## DESIGN MEMORANDUM NO 3-05

DATE: January 25, 2005

SUBJECT: Drainage Manual-Revisions in the Erosion Control Plan Development Process

SILT TRAP  
TYPE A

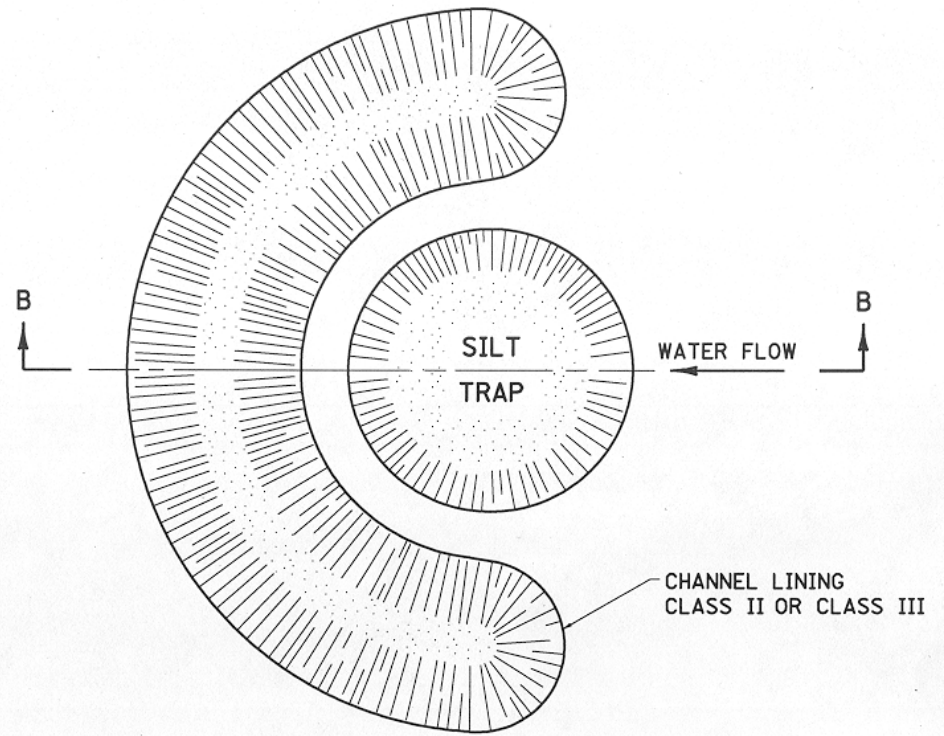
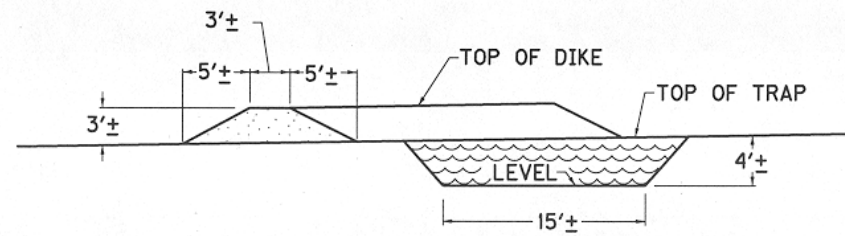
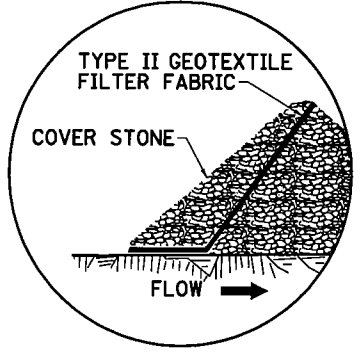
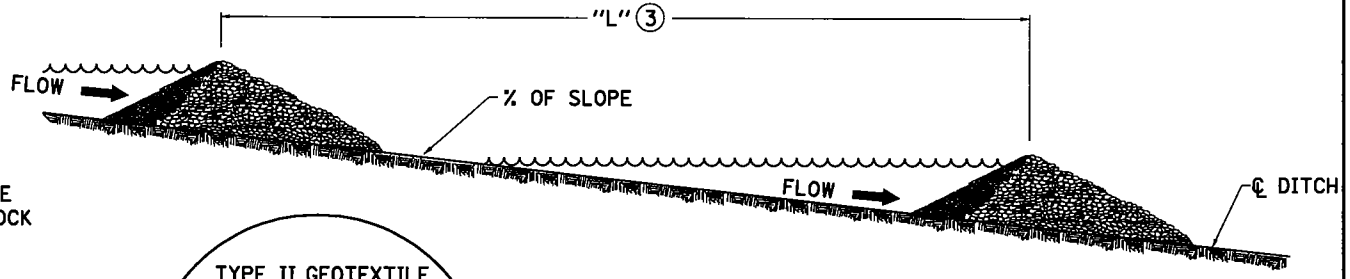
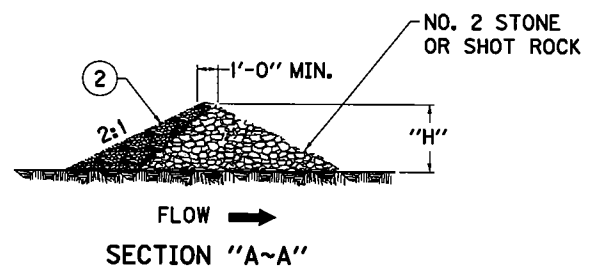
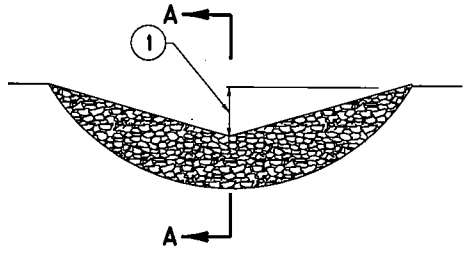
3. Silt Trap Type A and B shall be replaced with Silt Trap Type A. Standard Drawing RDX-220 will be discontinued. Refer to attached detail sheet for Silt Trap Type A. A corresponding bid item for each device installed and cleaned shall be shown on the Plans.

- a. Silt Trap Type A - Construct Silt Trap, Type A in natural or excavated channels. Traps may consist of pit, a berm or both. Pits shall be 2 to 4 feet deep, 20 to 30 feet long and 5 to 10 feet wide. Berms shall be no more than approximately 3 feet in height unless approved by the Engineer.

SILT TRAP TYPE B

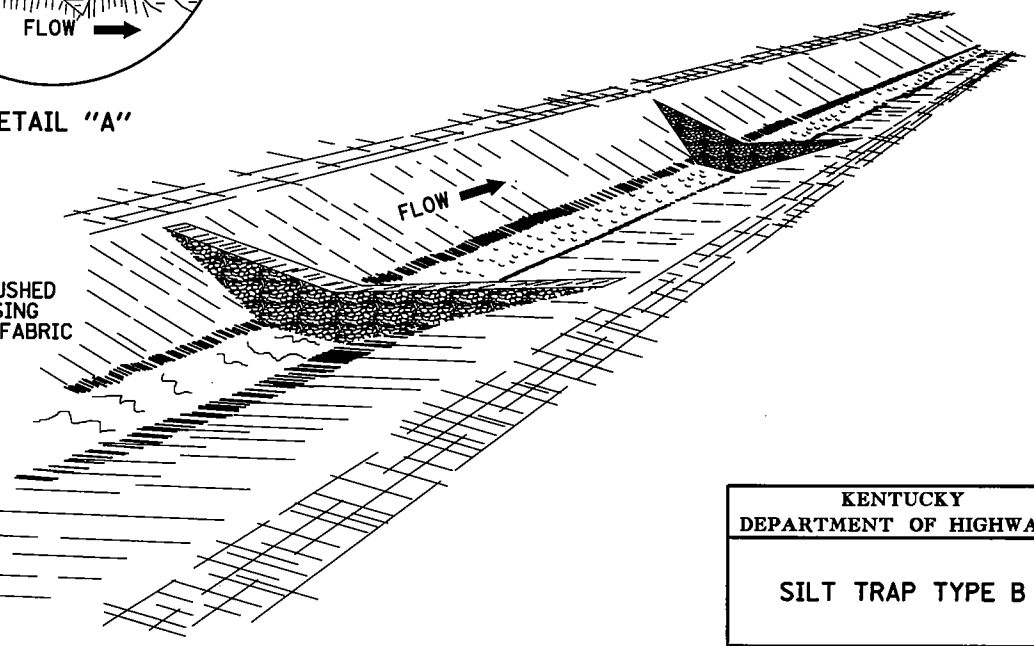
2. Silt Check, Type II and III shall be replaced with Silt Trap Type B. Standard Drawing RDX-205 will be discontinued. Refer to attached detail sheet for Silt Trap Type B. A corresponding bid item for each device installed and cleaned shall be shown on the Plans.

- b. Silt Trap Type B - Construct Silt Trap, Type B primarily in roadway ditches or excavated channels. Traps shall be composed of No. 2 stone or blasted rock of similar size, quality and gradation approved by the Engineer. A four inch minimum thick layer of crushed aggregate having 100% passing the 3" sieve and no more than 5% passing the No. 8 sieve shall be placed on the upstream face of the berm. This layer shall be underlain with Type 2 geotextile filter fabric.

SILT TRAP TYPE C

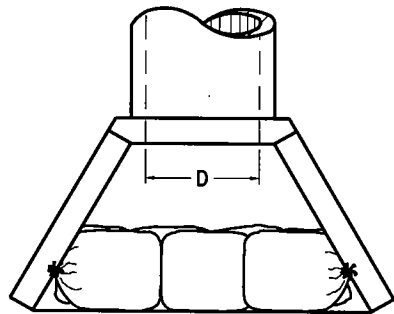
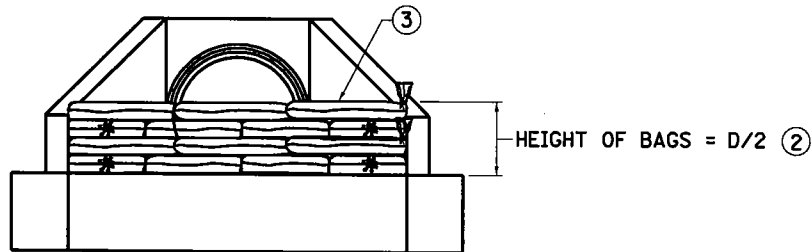
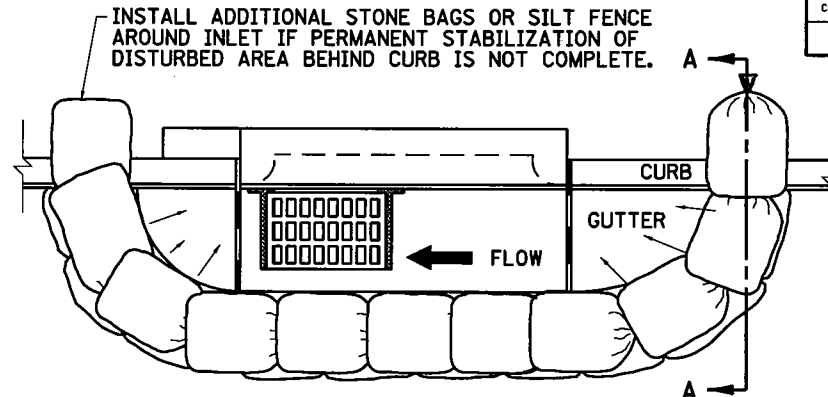
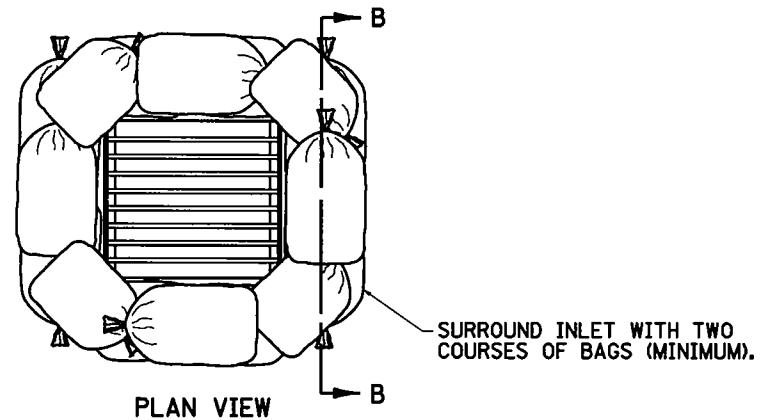
4. An efficient means to trap silt at inlets is needed; therefore Silt Trap Type C shall be added to the Standard Drawings. It consists of interlocking layers of bagged aggregate placed around curb inlets, drop box inlets and culvert inlets to protect them from siltation. Refer to attached detail sheet. A corresponding bid item for each device installed and cleaned shall be shown on the Plans. This trap shall not be placed in blue line streams.

- c. Silt Trap Type C - Construct Silt Trap, Type C at curb inlets, drop box inlets or culvert inlets. Traps shall consist of multiple rows of 18" x 30" interlocking bags composed of non-woven Type II geotextile fabric and filled with No. 57 stone. Silt Trap, Type C shall not be placed in blue line streams.
